***MODIFICATION REQUEST:
Mixed Use Redevelopment
110 – 114 Herring Road, North Ryde
(MP10_0112 MOD 2 & MP10_0113 MOD 1)***

Secretary's
Environmental Assessment Report
Section 75W of the
Environmental Planning and Assessment Act 1979

May 2014

Figure 4: Proposed modified central park open space (red hatching) areas and dimensions

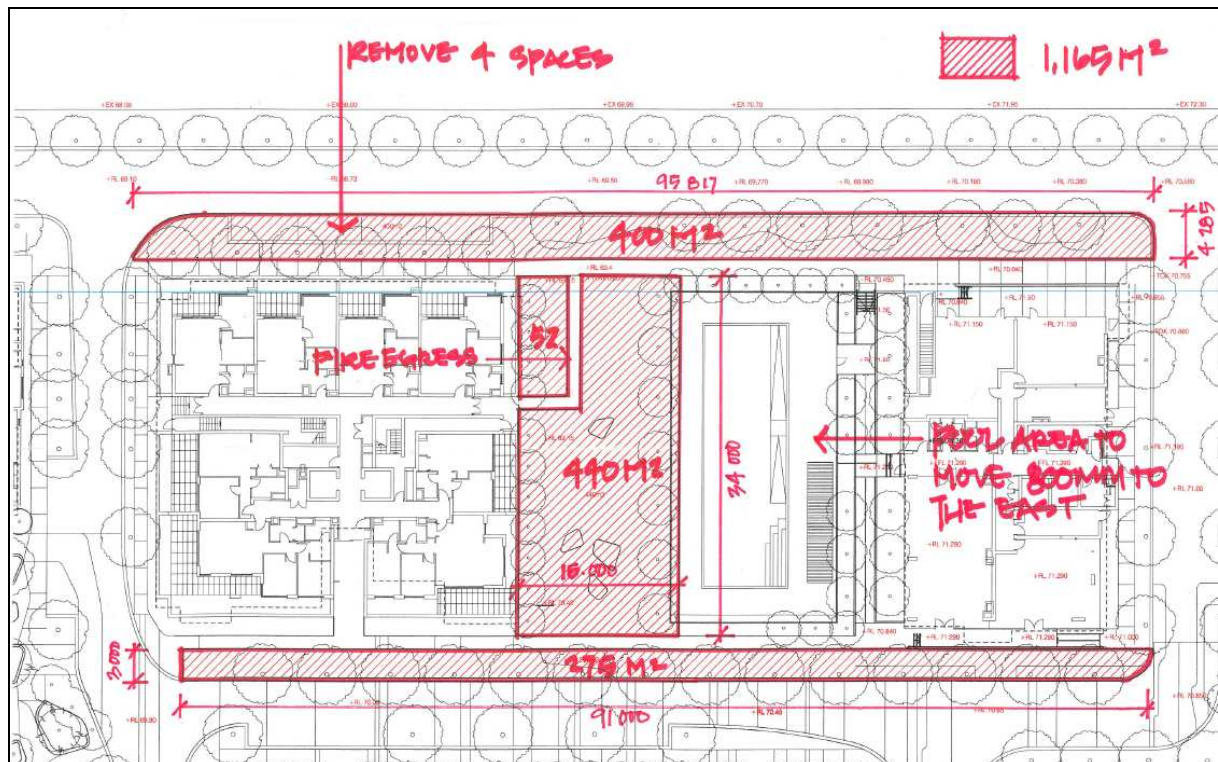
The application proposes to meet the requirements of Modification B4 by removing four car parking spaces, relocating the southern footpath to increase the open space width between the footpath and the internal street to 3m, and adjusting the location of the pool by moving it approximately 800 mm to the east (**Figure 4**).

While the area technically complies with the requirements of Modification B4, the department has raised concern with the proponent that the primary area of open space was only 492m², and that the proposal was relying on landscaped verges to the north and south to achieve the minimum 1,165m² (excluding the pool space of 500m²).

After considering the additional justification provided by the proponent, the department considers that the proposed area of open space meets both the numerical requirements and the intent of Modification B4. The series of open spaces (**Figure 5**) including the central park will provide good opportunities for passive and active recreation for residents, visitors and the public. The deletion of on-street car parking spaces allows for a wider landscaped area and also enhances the appearance of the development and an increased amenity for future residents. The department considers that sufficient parking is provided on the site as discussed in **Section 5.7**.

On this basis, the department considers that Modification B4 has been satisfied by the amended plans and recommends that this requirement is deleted.

Figure 5: Landscape and open space components of the approved project

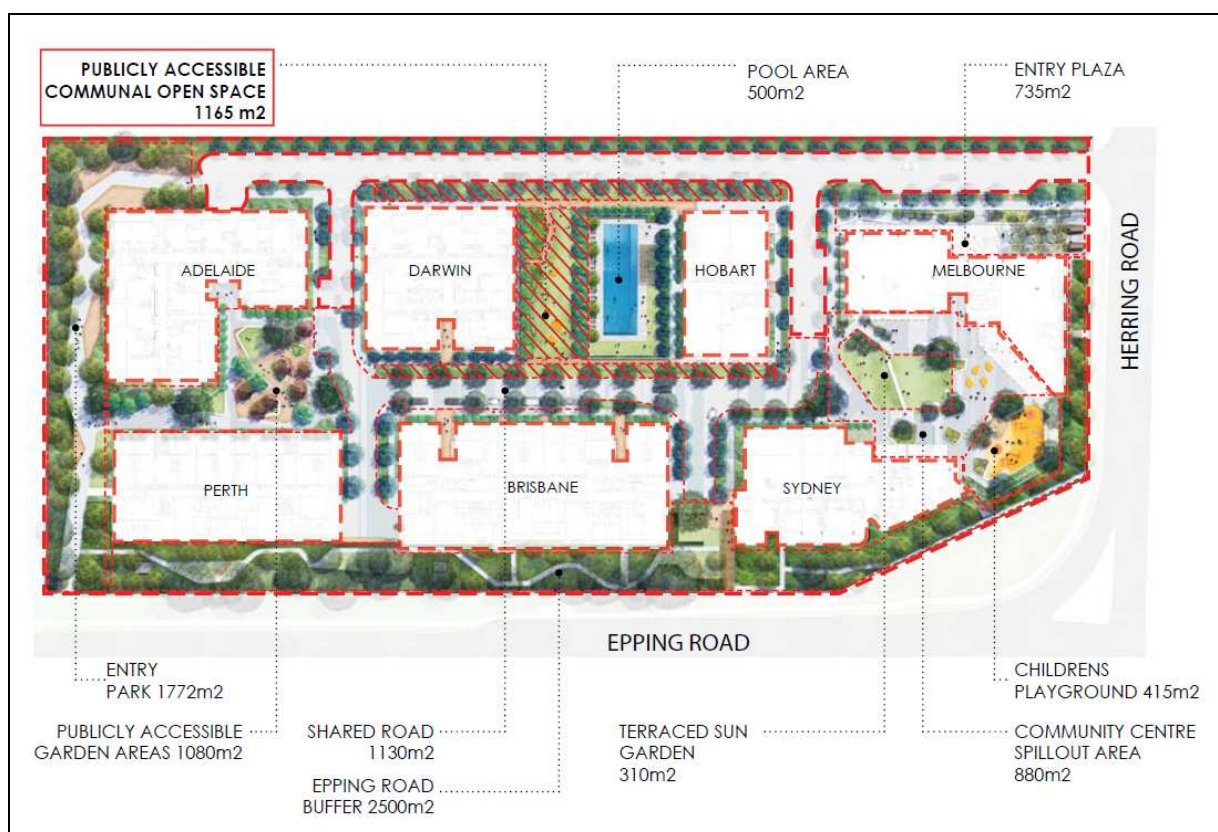
In response, the proponent argues that in addition to the main communal open space, the development provides a series of other open spaces, including children's playground, lawn terraces, outdoor seating, gardens and general landscaped footpaths with a total area of 12,825m² to be available for residents (**Figure 5**).

Figure 8: The Level 3 floor plan of Building C / the Brisbane Building as approved in Modification 1 to the Concept Plan (above) and proposed as part of this application (below)

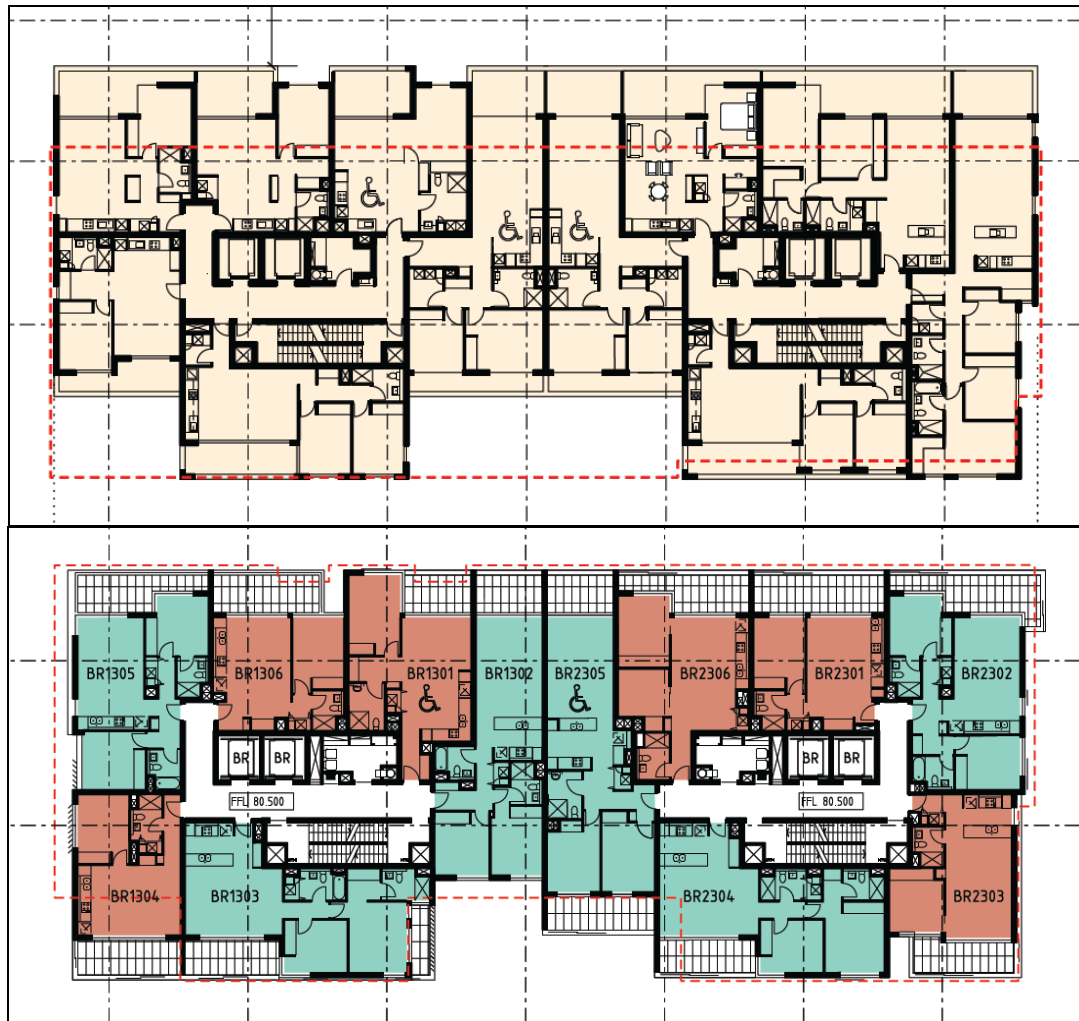
The currently proposed amended plans for the Brisbane Building include minor amendments to the building footprint and a revised internal layout to accommodate a revised apartment mix and reduced apartment sizes. This is shown in the proposed elevation in **Figure 7** and in the comparative internal layout plans in **Figure 8**. The overall building footprint is generally consistent with the Concept Plan and does not exceed a height of RL 116.25. The main changes are as a result of varied articulation/recessing, window and balcony placement.

The department has considered the internal and external amendments to Building C/ the Brisbane Building and notes that the amendments to the building footprint are within the original approved building footprint. The external elevations are considered acceptable and provide an improved level of variation, articulation and visual interest than the approved plans under Modification 1 to the Concept Plan.

It is considered that the amended plans satisfy the requirements of Condition B1 and it is recommended that this part of the condition be deleted.

Figure 9: The South elevation of Building W / the Perth Building as approved in the Concept Plan (subject to modification) (above) and in Modification 1 (below)

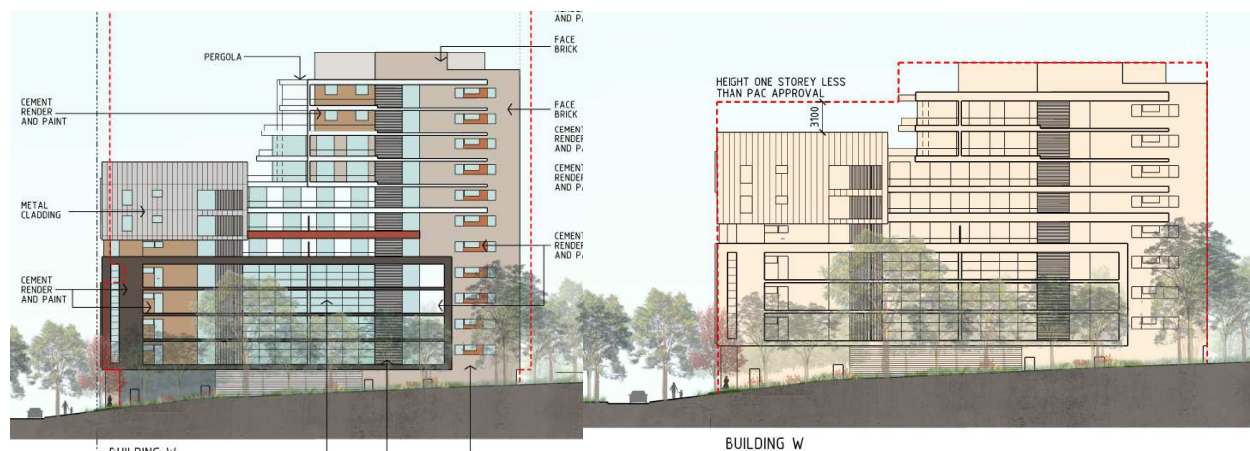
The Concept Approval (as modified) approved amended plans for Building W (now known as the Perth Building) which included a reduction in height from RL 115.05 to RL 105.95 as outlined in **Figure 9** below.

Figure 10: The South elevation of Building W as proposed within this application.

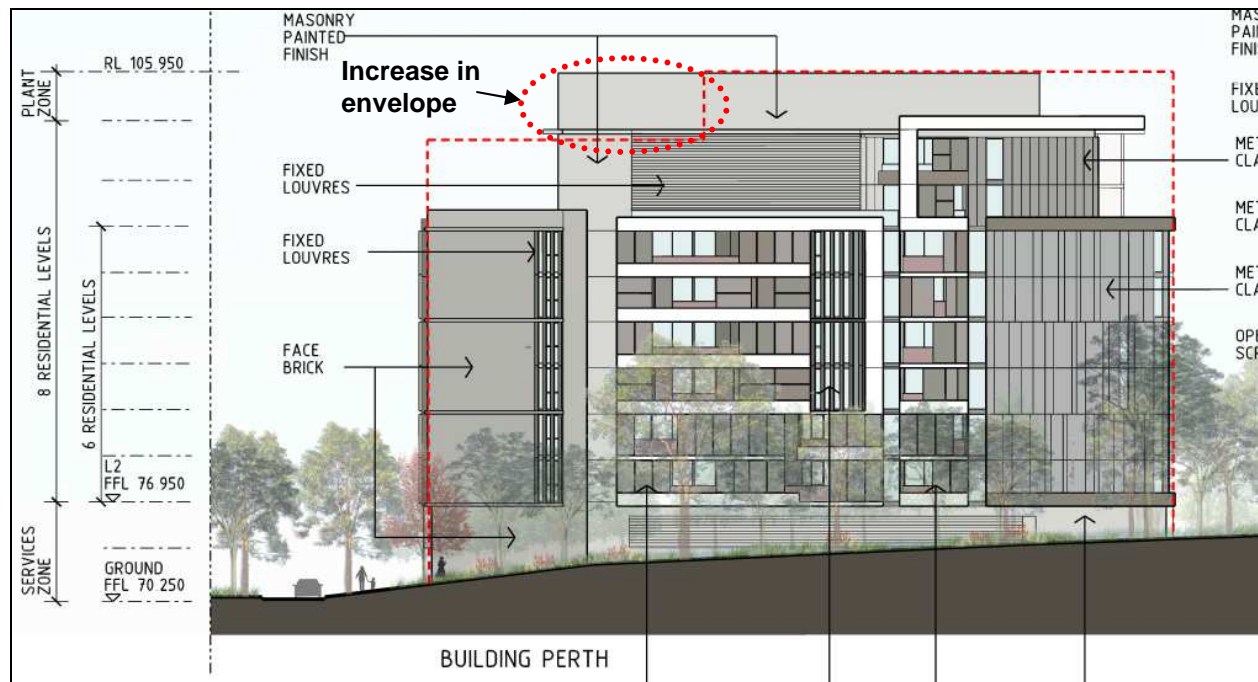
This has resulted in changes to the external elevations by way of varied articulation/recessing, window and balcony placement. Further, the building envelope at the uppermost level has been increased in the north-western corner of the building as shown **Figure 10**.

The department has considered the internal and external amendments to Building W / the Perth Building and, notwithstanding the increase in the north-west corner, considers that the plans meet the requirements of Condition B1 of the Project Approval which requires that the 13 storey portion of Building W (RL 115.05) be reduced to 11 storeys (RL 105.95). The external elevations are considered acceptable and provide an appropriate level of variation, articulation and visual interest to break up the bulk of the building.

It is considered that the amended plans satisfy the requirements of Condition B1 of the Project Approval and it is recommended that this part of the condition be deleted.

Figure 11: The Level 3 floor plan of Building W / the Perth Building as approved in Modification 1 to the Concept Plan (above) and proposed as part of this application (below)

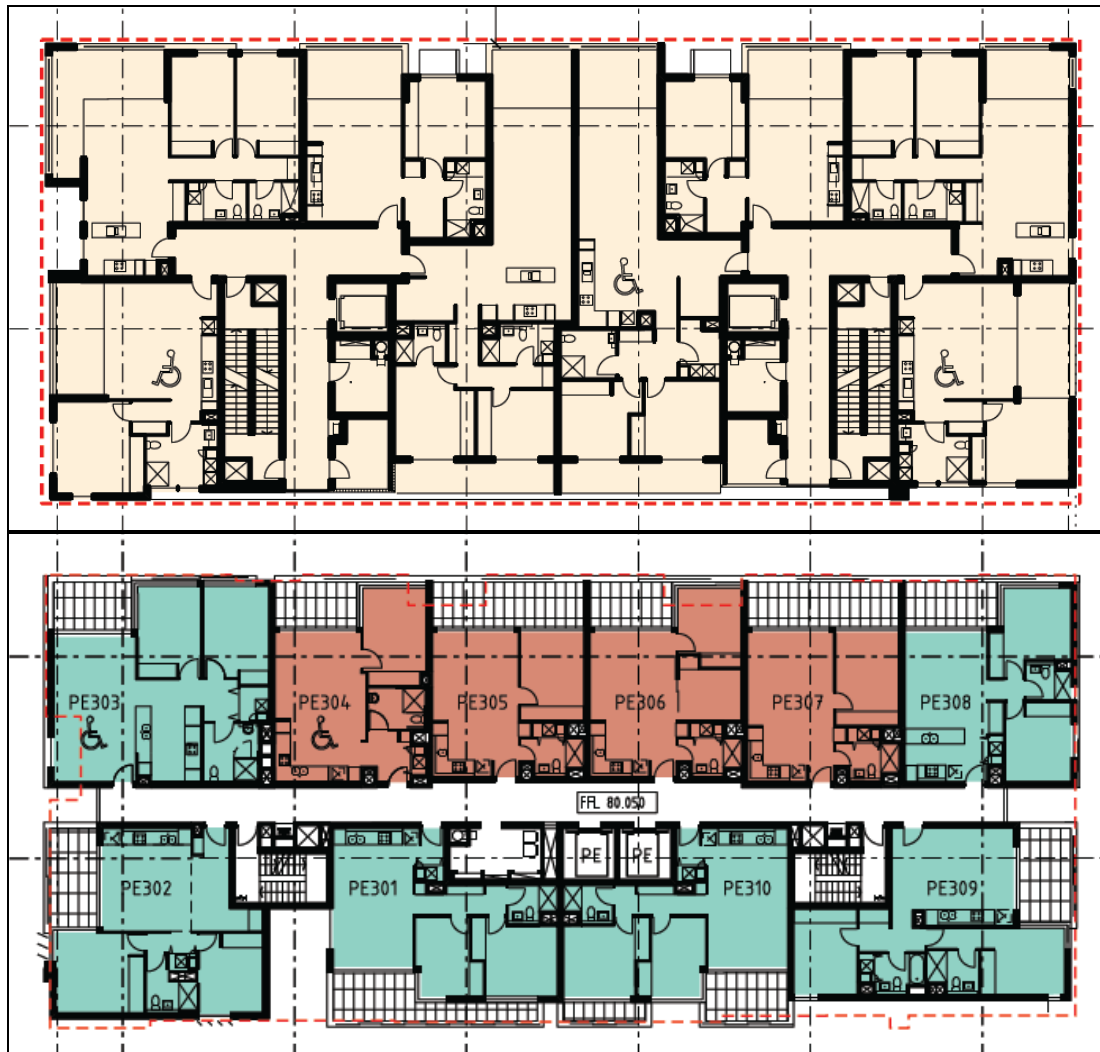
The proposed amended plans for the Perth Building include a revised internal layout to accommodate a revised apartment mix and reduced apartment sizes accessed off a single core (**Figure 11**).

However, the Perth Building has been reconfigured from 2 cores to a single core serving 10 apartments. In this instance, the department considers that this is acceptable, as the east and west ends of the corridor have access to natural light which provides a good level of amenity within the corridor. Further, the entries to apartments are sufficiently spaced and offset to provide an appropriate level of privacy and amenity.

Figure 13: Western elevation of Building H / the Adelaide Building – as approved (left) and proposed (right)

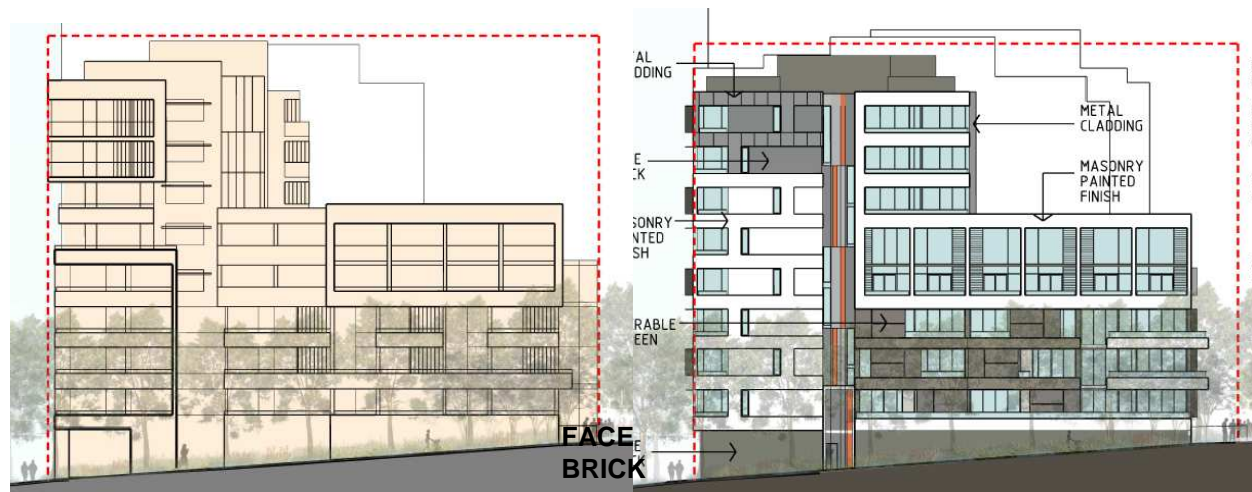
- Modification B3 - *"The street to ground level wall of Building H, on both street frontages (north eastern and north western elevation) shall be amended to replace any rendered/painted walls with wall materials with an integral finish such as fair faced brickwork or stone"*.
- Condition B1 - *"The street to ground level wall of Building H, on both street frontages of the north eastern and north western elevations shall be amended to reduce the blank rendered/painted wall effect and to provide greater articulation and visual interest. Consideration should be given to changing balustrade material to reduce the height of the wall"*.

The proponent has replaced the rendered/painted walls at the street to ground level with face brick as outlined in the above requirements (**Figure 12 and 13**). The department notes that the alternate finish to the street to ground level lessens the apparent height of the wall, and this design modification is supported.

It is considered that the amended plans satisfy the requirements of Modification B3 of the Concept Plan and Condition B1 of the Project Approval and it is recommended these conditions be deleted.

Figure 14: The Level 3 floor plan of Building H / the Adelaide Building as approved in Modification 1 to the Concept Plan (left) and proposed as part of this application (right)

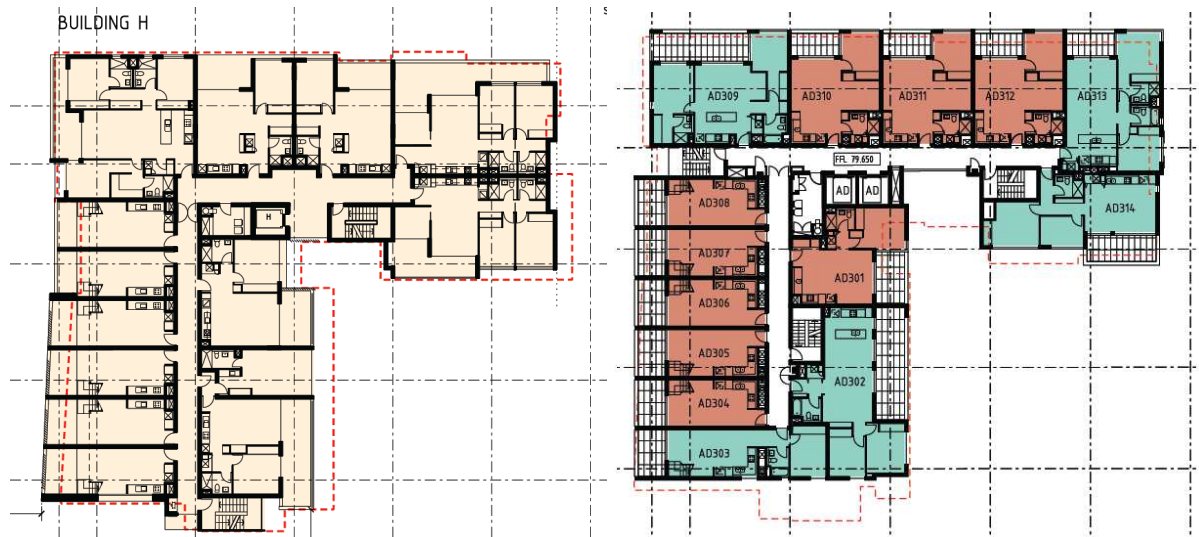
The department also notes that the internal floor plan and footprint of Building H / the Adelaide Building has been amended, which includes varied articulation, balcony and window placement (**Figure 14**). Further the envelope of the upper levels in the northern corner of Building H / the Adelaide Building has been increased. However it is noted that the modifications are within the original approved building envelope and are therefore considered acceptable.

Figure 15: The Level 3 floor plan of Building Y / the Darwin Building as approved in Modification 1 to the Concept Plan (left) and proposed as part of this application (right)

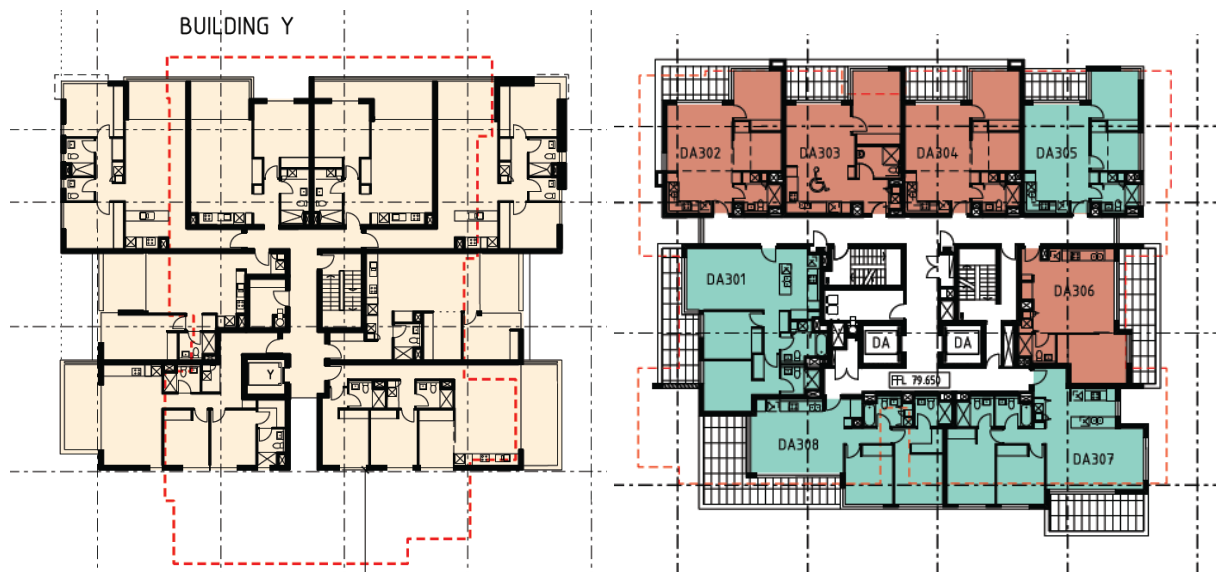
Although no amendments were required to Building Y / the Darwin Building within the Concept and Project Approval, the proponent has made internal and external amendments to this building, as part of its overall configuration to accommodate a greater number of smaller apartments. This has resulted in minor amendments to the building footprint as outlined in **Figures 15 and 16**.

The department has considered the internal and external amendments to Building Y/ the Darwin Building and notes that the amendments to the building footprint are within the original approved building footprint. The external elevations are considered acceptable and the department considers that they provide an improved relationship with the ground level and greater variation, articulation and visual interest than the approved plans under Modification 1 to the Concept Plan.
